Subject: Response to Alameda County Health Letter of May 23, 2006 regarding Workplan for Groundwater Characterization and Interim Corrective Actions
2836 Union Street, Oakland, California
Alameda County Environmental Health Case No. RO0002901

PROPOSED WELLS AND CORRECTIVE ACTION AREA

2836 Union Street, Oakland, CA

Figure 2

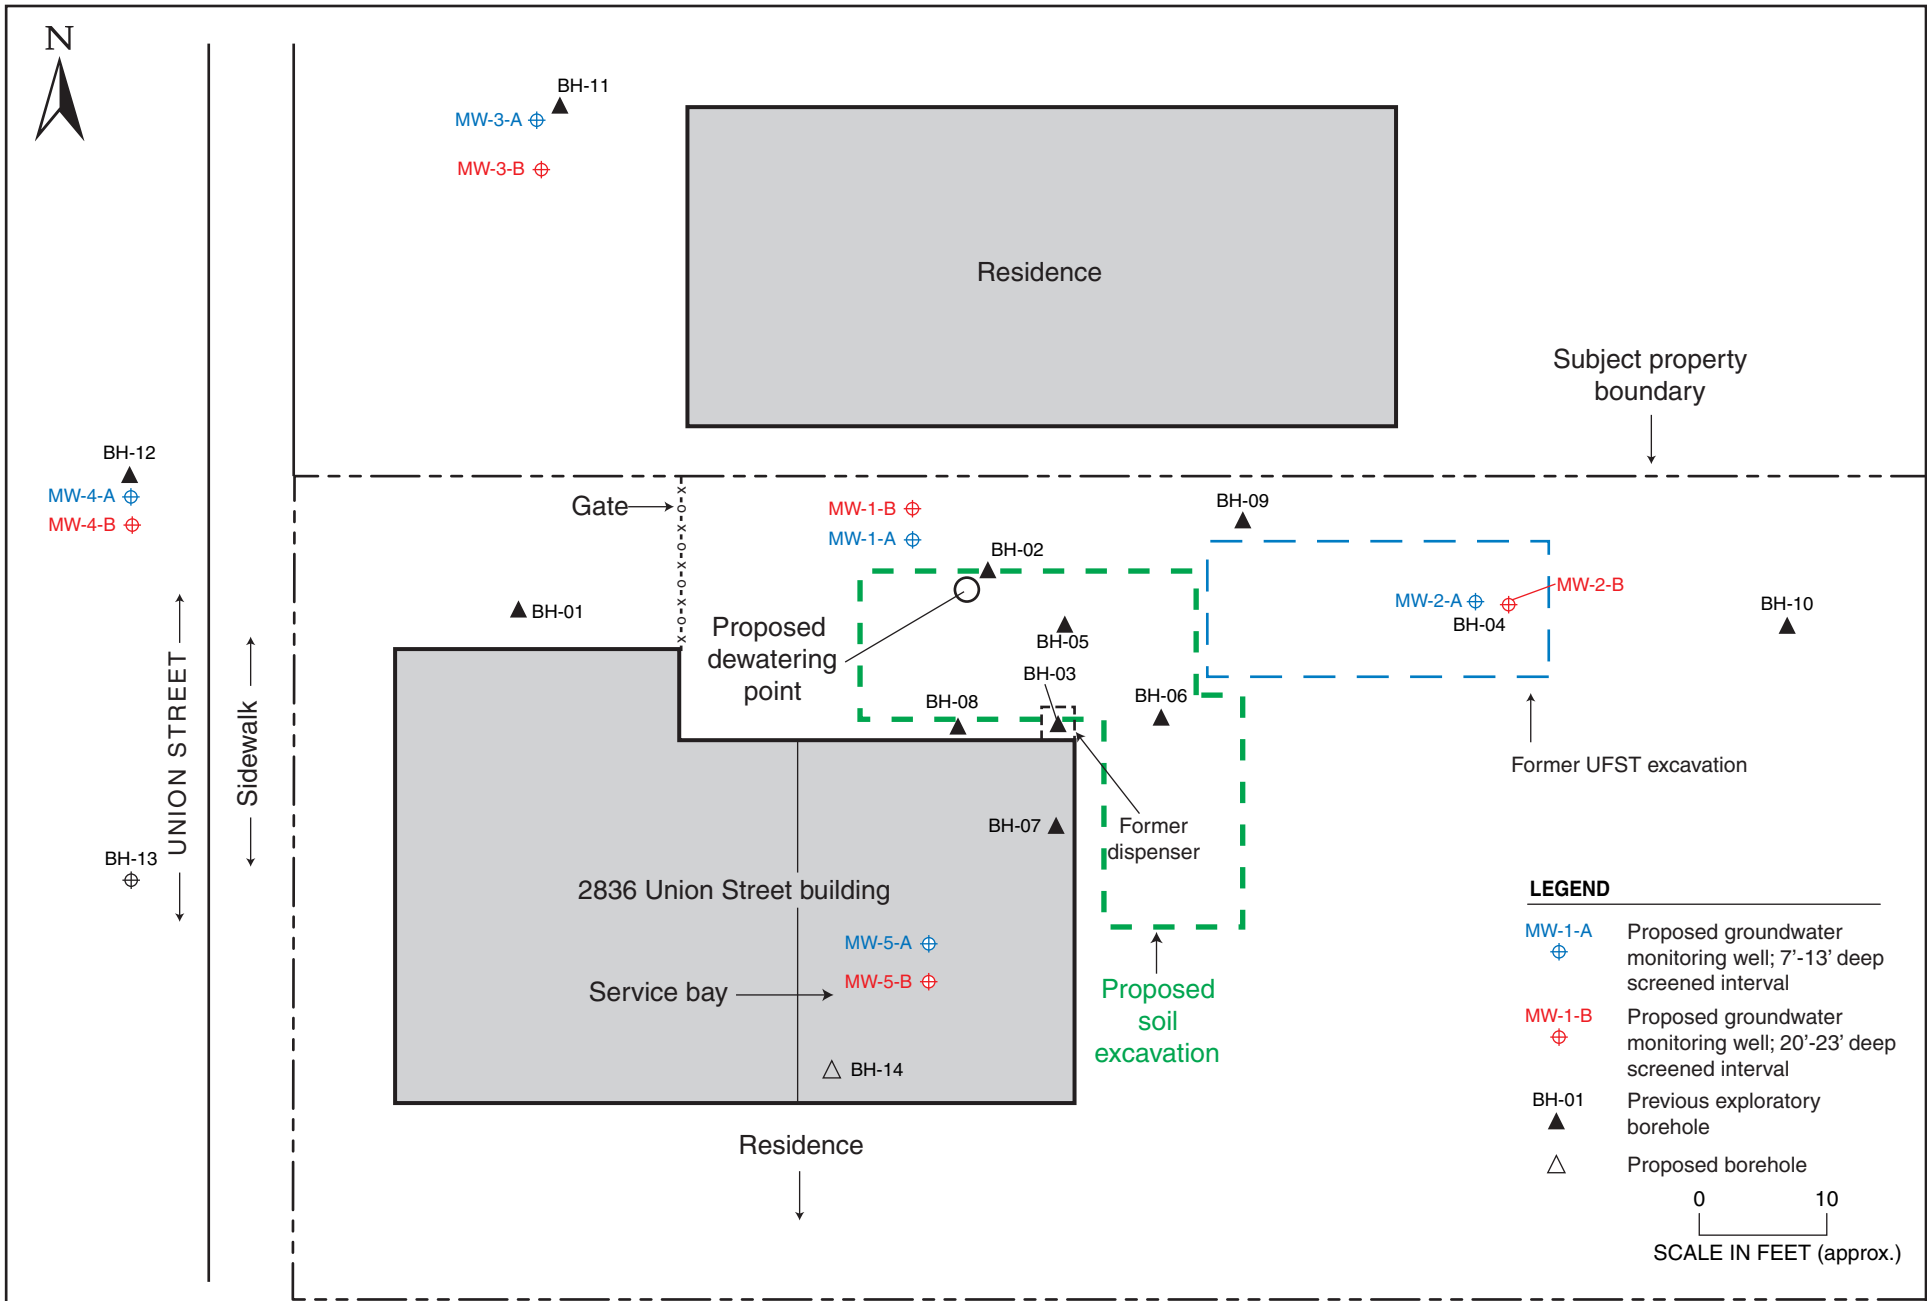
Three additional boreholes will be advanced inside the building to further evaluate the extent and magnitude of soil and groundwater contamination in this area. One borehole (BH-14) will be advanced at the extreme southwest corner of the service bay, approximately 30 feet southwest of the former dispenser, and will be advanced to the full program depth (approximately 25' bgs). Midway between BH-14 and the dispenser area we will advance two clustered boreholes, which will be converted to groundwater monitoring wells (screened in the upper and lower water-bearing zones).

A total of 10 groundwater monitoring wells will be installed at 5 locations, as shown on the revised Figure 2, including one well inside the building. At each location, two wells will be

installed (each a separate small-diameter casing installed in a closely-spaced but separate borehole, with a separate well box). One well will be installed in the upper water-bearing zone (screened from 7' to 13' deep) and one will be installed in the lower water-bearing zone (screened from 20' to 23' deep). We propose to revise (from the original workplan) the well screened intervals, based on availability of commercially-available pre-packed well screens. Wells monitoring the 10 foot-deep water-bearing zone will have 6-foot screen lengths (two 3-foot long sections) and wells monitoring the 20 foot-deep water-bearing zone will have 3-foot screen lengths.
